BULLETIN

From Atari Field Service

Date July 30, 1982

DIG DUG™

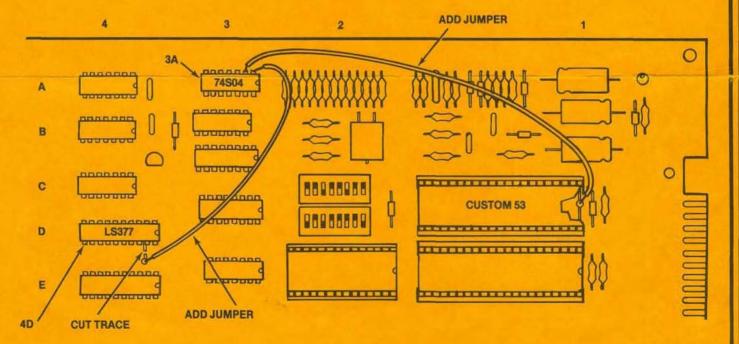
Problem:

Four credits for one coin

Modification:

- 1. Cut trace between pins 18 & 19 of LS377, located at 4D (see illustration below).
- 2. Jumper pin 1 of 74S04 at location 3A to the feed-through, as show below.
- 3. Jumper pin 2 of 74S04 (at location 3A) to feed-through between pins 1 & 42 of the custom integrated circuit at location 1/2C (see illustration below).
